A303 Amesbury to Berwick Down

TR010025

**8.36 - Comments on any further information requested by
the ExA and received at Deadline 4**

July 2019

FIGURE 11.4 GROUNDWATER ABSTRACTION AND SOURCE PROTECTION ZONES

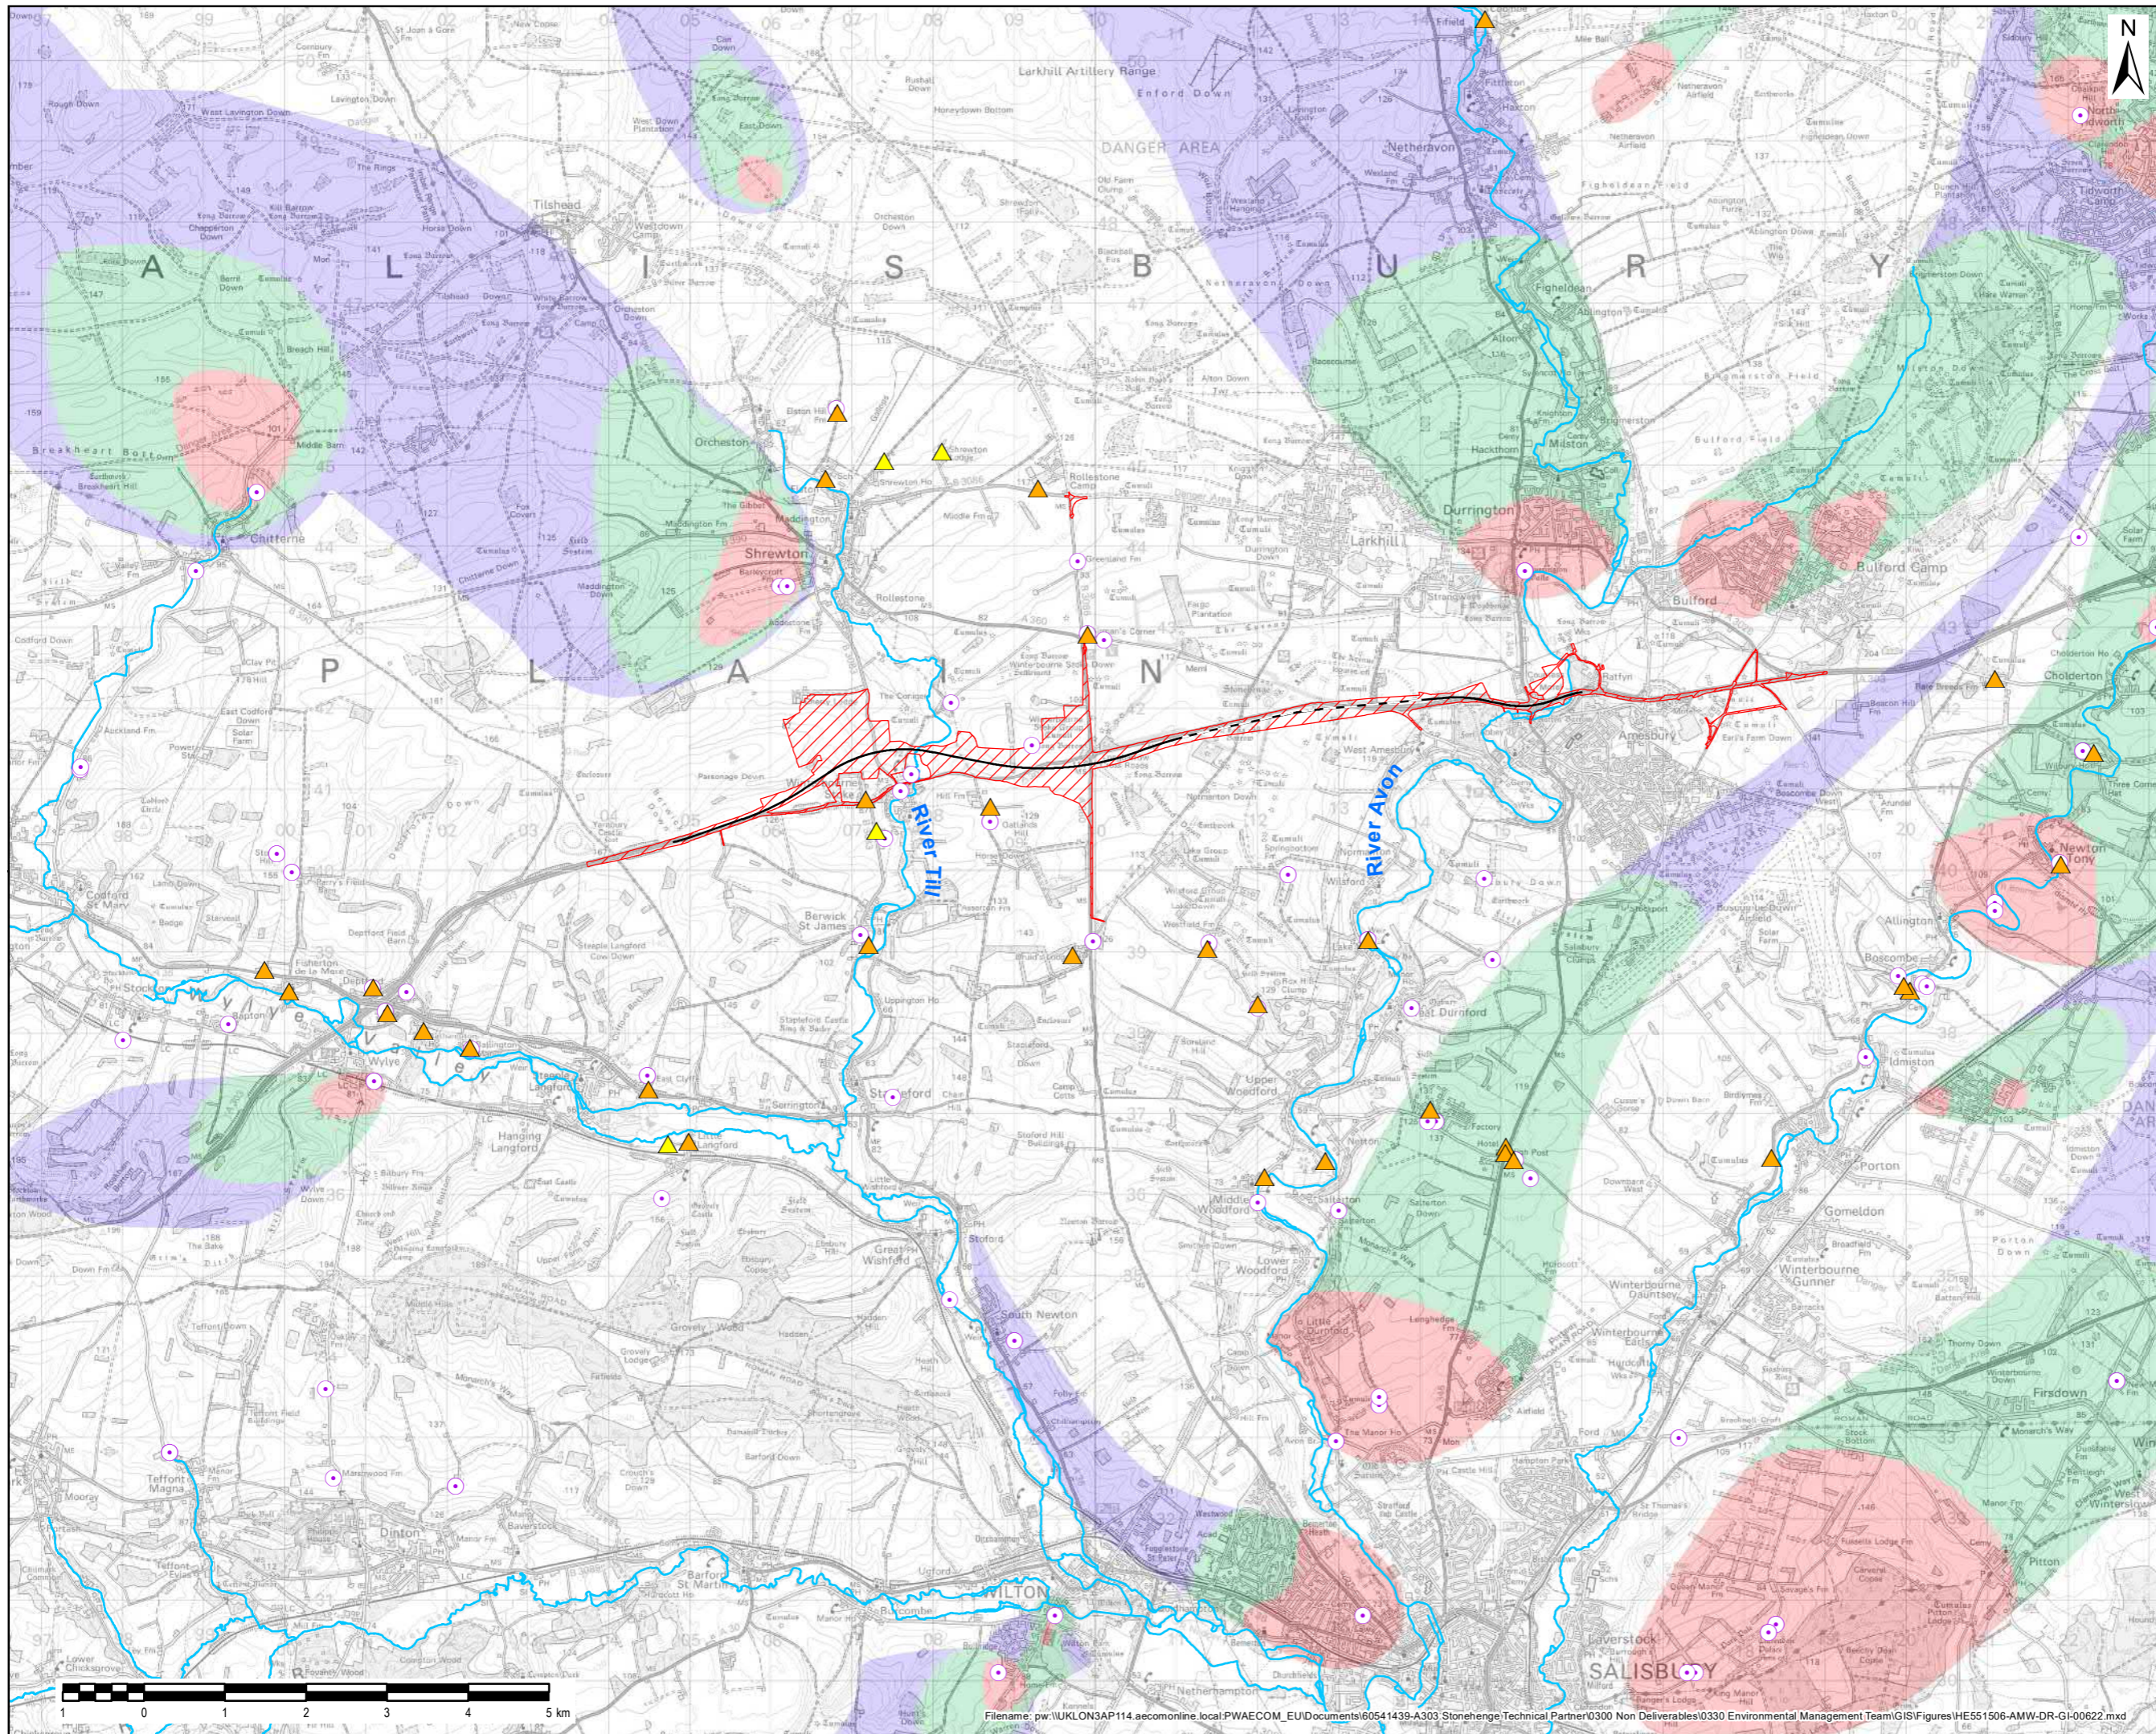
31.1	Oral Submissions	
	Matter Raised	Highways England's Response
31.1.1	<p>During the Hearing the Inspectors were shown: FIGURE 10.5 GROUNDWATER SOURCE PROTECTION ZONES, GROUNDWATER ABSTRACTIONS AND RIVERS WITHIN THE GEOLOGY AND SOILS STUDY AREA. The representative of Highways England used the plan to show those groundwater receptors (abstractions) that are positioned in close proximity to the proposed alignment.</p> <p>My client does in fact have a licenced abstraction that is not marked on the Fig 10.5. Highways England was made aware of this missing information through response to consultation dated 19th April 2018. Copies of the abstraction licences were subsequently sent to Highways England.</p> <p>We were then informed accordingly that the Environmental Statement was updated and an explanation given as to why this abstraction was not assessed in the first instance. This confirmation was provided in the Consultee record of Engagement</p> <p>ID: SH230418-10.</p> <p>[Relevant extract and copy of abstraction licence attached to written submission].</p>	<p>The Figure shown in the Issue Specific Hearing 4 was Figure 11.4 Rev 01 (as submitted in the Environmental Statement [APP-178]). This does omit Borehole E. The Figure has been updated and is attached in Appendix A of this document (Figure 11.4 Rev02). The five boreholes are shown on the Licence Drawing, also attached in Appendix A of the document. None of the abstraction points on the licence (including E which is further away from the Scheme than the other four assessed boreholes) are predicted to be impacted by the scheme.</p> <p>For further explanation see response below in paragraph 31.1.3.</p>

Figure 11.4 of the Water Chapter of the ES [APP-049] shows the four borehole locations. An updated version of Figure 11.4 is attached to include the fifth borehole and the updated licence (no longer pending in the Key.) The borehole that was omitted is further from the scheme than the other four boreholes and therefore at lower risk.
